# Revised Design Review Recommendation

March 19th, 2013

505 Madison St is a 36 story commercial office building with street level retail with seven levels of below grade parking. It is located on the west side of the block bounded by 5th Avenue, Madison Street, Marion Street and 6th Avenue.

## 2008 PLAN PROPOSAL

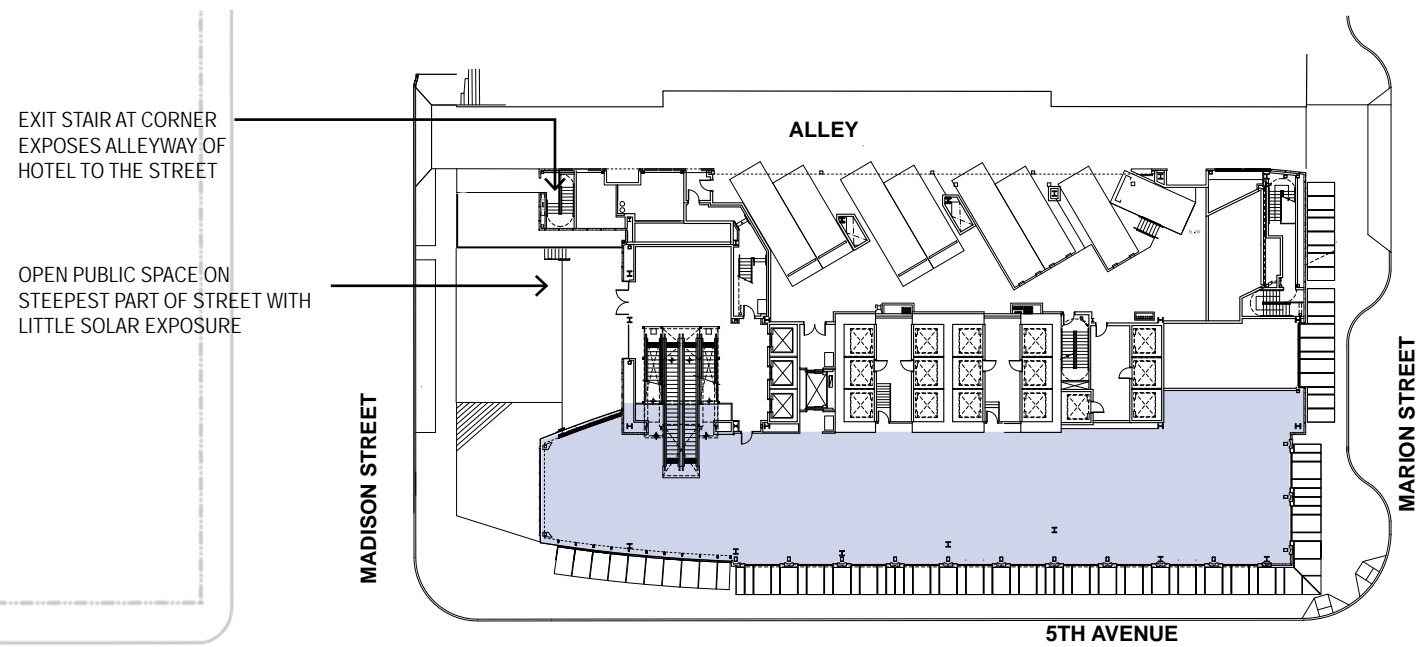
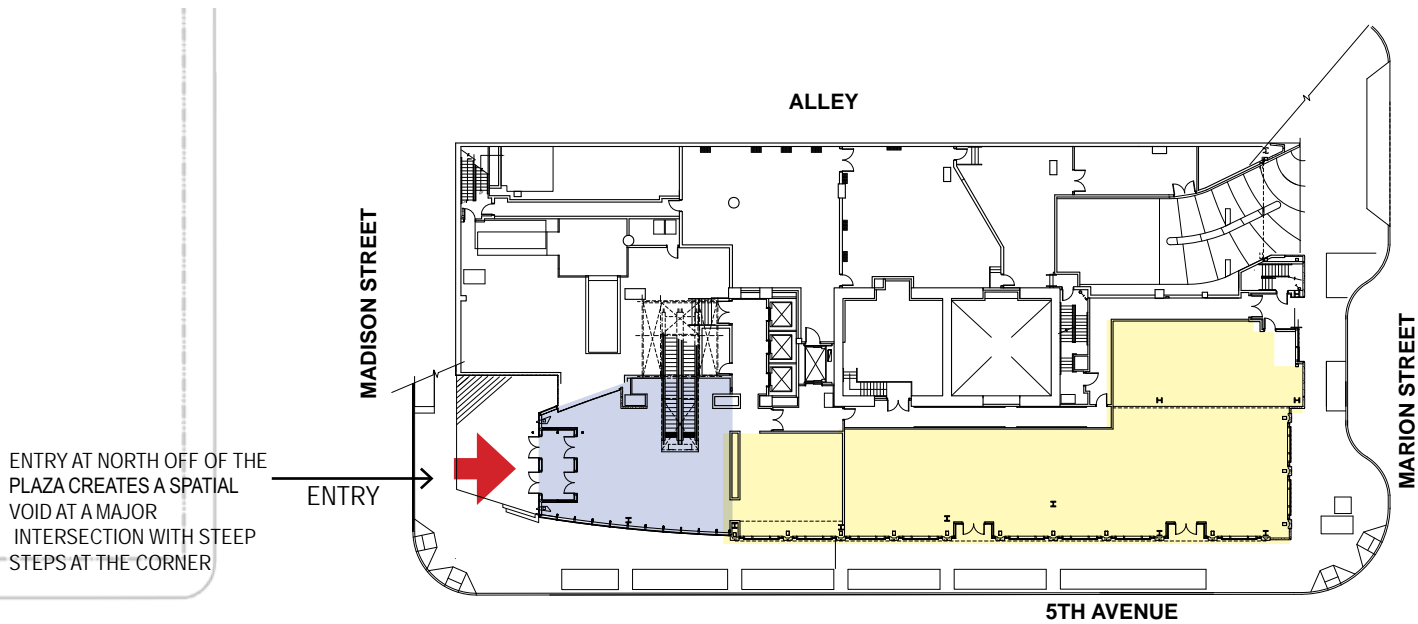
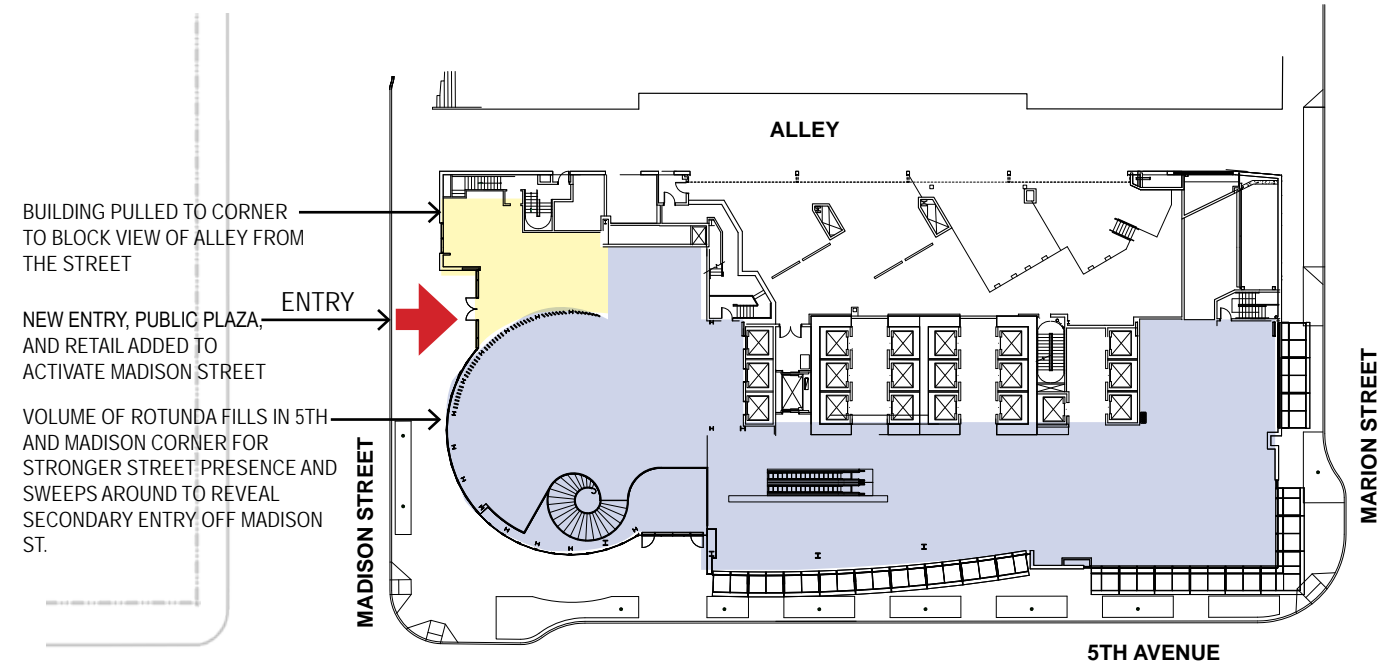
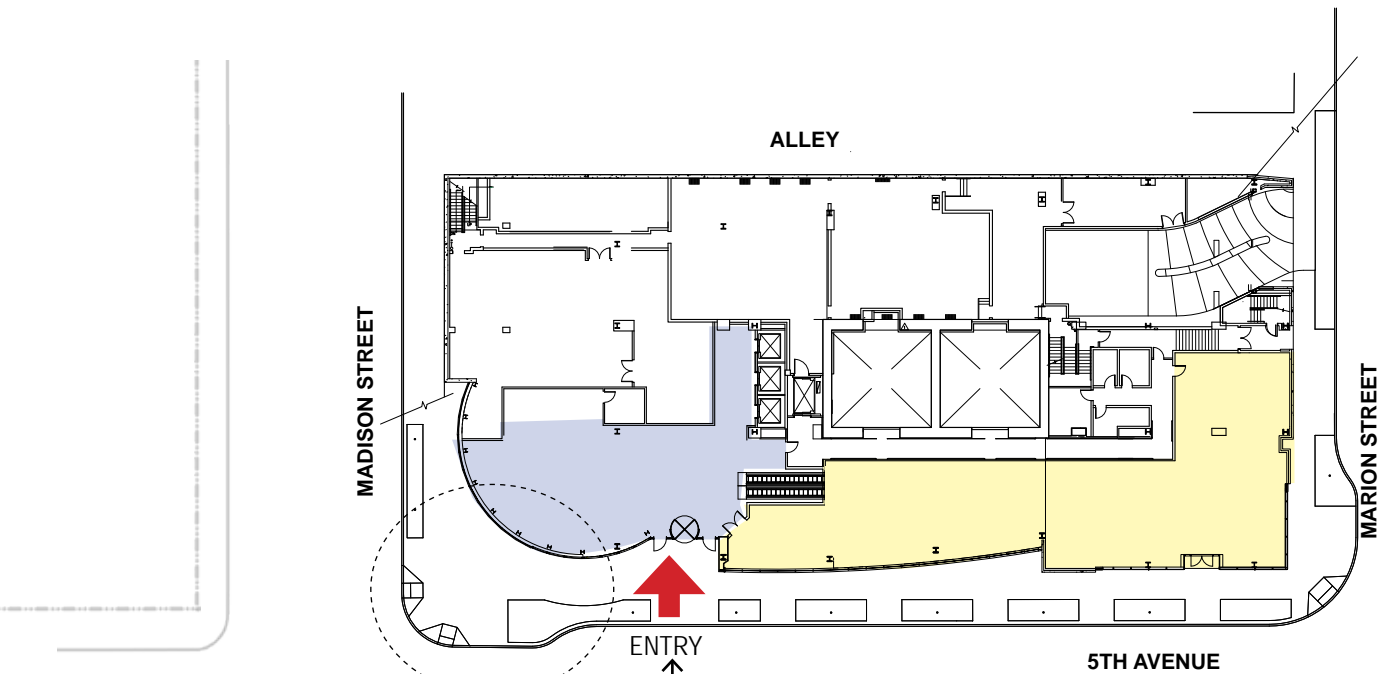
1. The façade at street level on Madison is redesigned to remove a dark, north facing open space. The new design reorients the open space to the corner of 5th and Madison with greater solar exposure, landscaping and space for public seating.

2. The new design activates Madison St by locating a retail use (coffee shop) up the hill adjacent to an open space for café seating.
3. The corner of 5th and Madison is now filled by a curvilinear 50' tall rotunda volume featuring a major interior open space that brings year-round activity and life to the neighborhood. In the prior design, the corner was a void, filled with steep steps and serving as a partial entry plaza to the north facing building entry. The rotunda is now designed to sweep back to reveal the main building entry along 5th Avenue. A second building entry has also been added on Madison Street.

Item	Area of Change	Type of Change	Design Guidelines
1	North Façade Street Level	The change to the north facade street level removes a potentially dark, north facing unusable open space oriented off Madison St near the alley and replaces it with an active retail use(coffee shop) along Madison and 5th Avenue(restaurant). Public open space with amenities is also now oriented further down the hill towards the corner of 5th and Madison where there is more solar exposure.	A-1 Respond to the physical environment D-1 Provide inviting and useable open space D-2 Enhance the building with landscaping  Redesign reinforces DRB recommendation to provide extensive retail frontage by adding a retail use up the hill on Madison in the form of a coffee shop with an adjacent small plaza. It also reinforces DRB recommendation to encourage useable open space and enhanced landscaping by providing a curved landscaped planter north of the rotunda, ample planting areas, benches, and seating areas at the corner of 5th and Madison which extends into the street ROW. In addition, reorienting the public open space from a dark, north-facing area removed from the street to a more prominent area with more solar exposure better responds to the physical environment, per Design Guideline A-1.”

2	Main Building Entry	In 2008, the main entry was located on Madison off a north facing entry plaza that was a void, with steep steps going up the hill on one side. The 2013 redesign locates the main entry off 5th Avenue, adjacent to a major rotunda element at the corner of 5th and Madison. A second entry is also now introduced off the coffee shop up the hill on Madison St.	A-1 Respond to the Physical Environment C-4 Reinforce Building Entries  To reinforce the building entries, the rotunda is designed to sweep back to reveal the main building entry along 5th Avenue. The curvilinear form of the rotunda also connects the 5th Avenue entry with the entry adjacent to the coffee shop on Madison St. The new main entry off 5th Avenue is also more prominent and easier for the public to access, which is more responsive than the original design to Board recommendations and design guidelines A-1 and C-4.”

2013 MADISON ST. ELEVATION

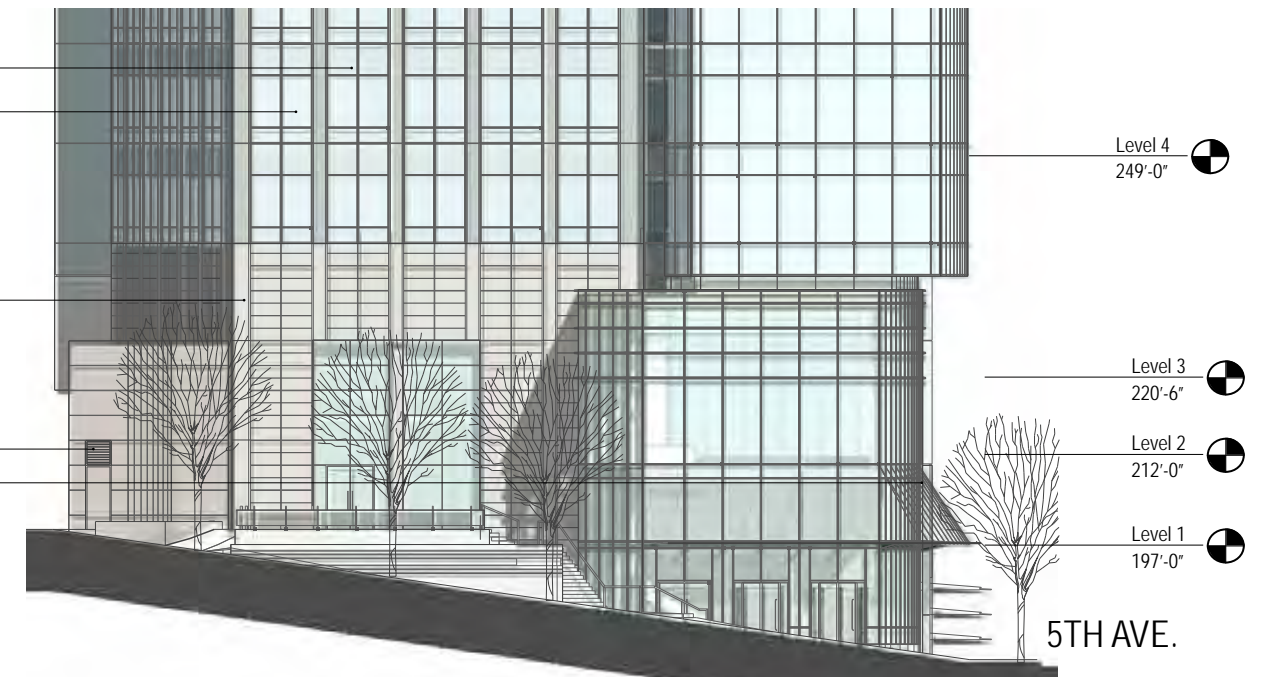
5	Podium Façade Along Marion St	The canopies along Marion have also been redesigned to meet canopy height requirements.  The 2008 design had also introduced a tall glazed element in the mid block zone on Marion St that was over an exit door that was not an entry into the building. The 2013 podium is redesigned to bring the visual emphasis not to the midblock zone but to the corner of 5th and Marion, where the corner window element is raised 29 feet higher than before to bring visual primacy to this area. The mid block zone of the podium is now articulated as a three story element with greater opacity to contrast with the more transparent corner expression.	C-2 Design a Façade of Many Scales C-4 Design Active Not Blank Facades  Design reinforces DRB recommendation to provide code required continuous overhead weather protection along Marion St. The canopies have also redesigned to no longer require a design departure for canopy height.

2013 5TH AVE. ELEVATION

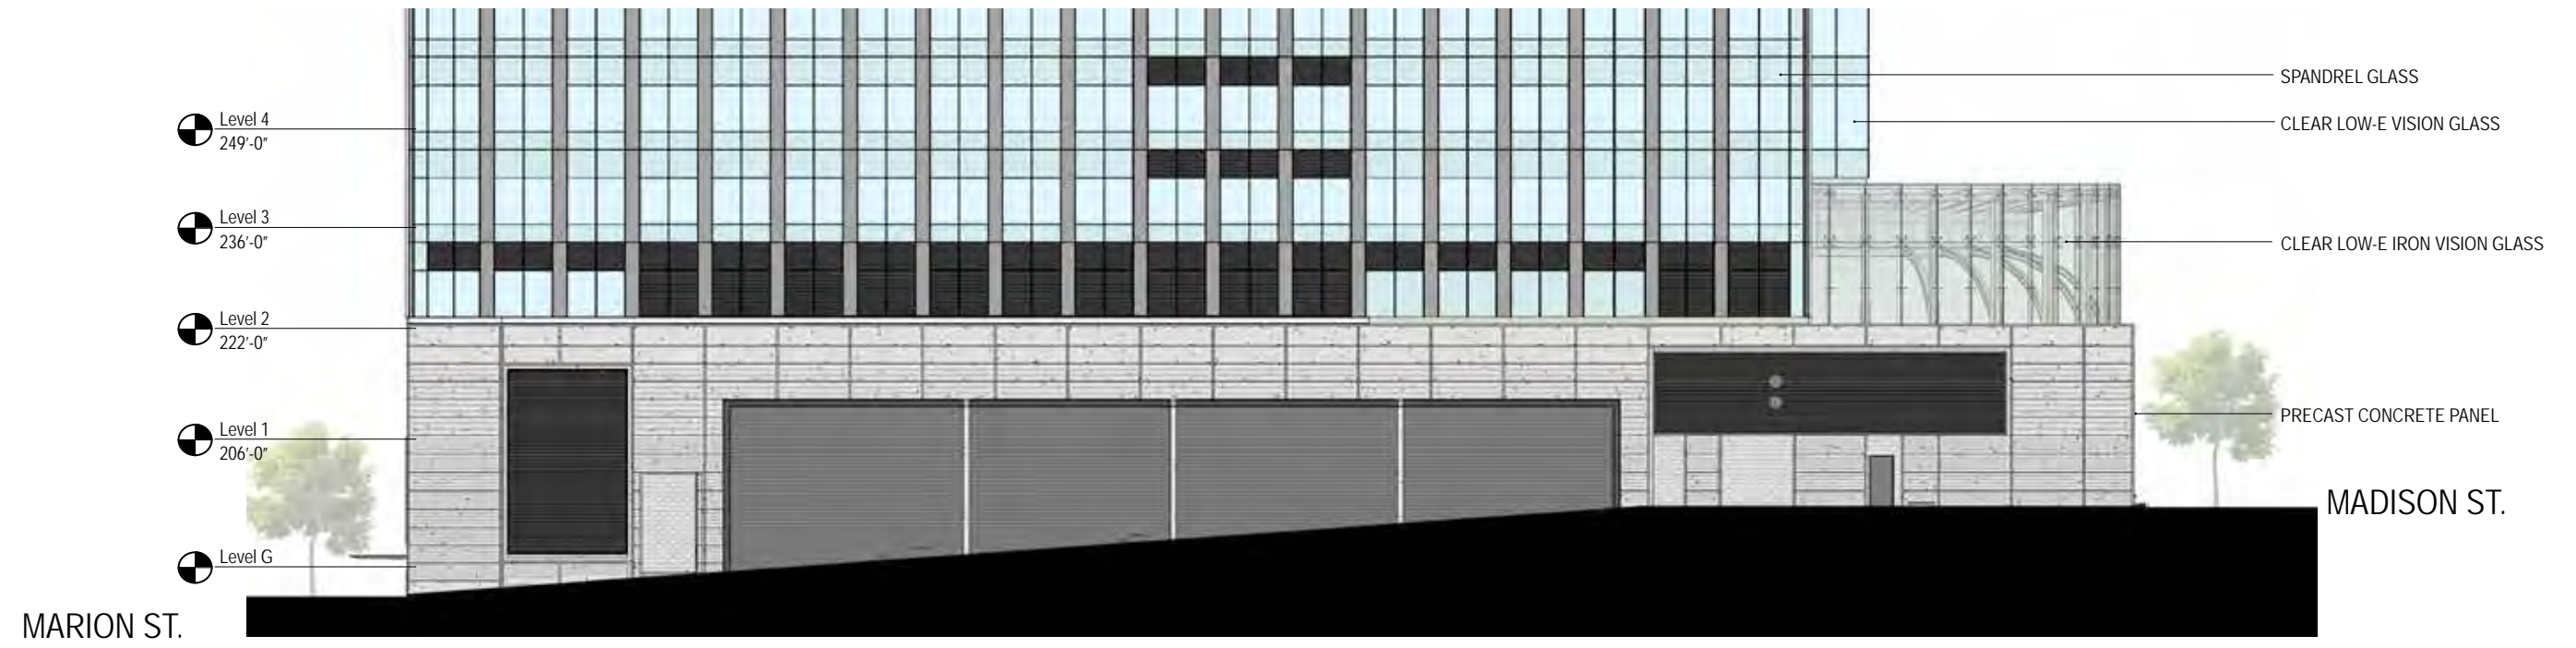
4	Podium Façade Along 5th Avenue	In 2008, the curved façade of the office tower had an abrupt transition to the rectilinear geometry of the podium. In the 2013 redesign, the curved form of the tower is now extended into the curved form of the podium at the building base and reinforced by the sweep of the rotunda to the north.  The 2013 5th Avenue facade also is scaled to the pedestrian experience along the entire block. It is broken up into four distinct elements: the rotunda, entry, curved mid block area and the rectilinear corner element that supports the "shoulder" from the office tower above.	B-2 Create a transition in bulk and scale B-4 Design a well proportioned and unified building  Curvilinear Rotunda form reinforces DRB recommendation to be responsive to the courthouse lawn, Seattle Public Library and the Methodist Church. The redesign also avoids the abrupt transition from the façade to the podium in the 2008 design and creates a gradual transition in bulk and scale by extending the curved form of the tower into the curved form of the podium at the building base. The redesign results in a more unified and well-proportioned building by integrating the rotunda, entry, curved mid-block area and the rectilinear corner element along the façade.
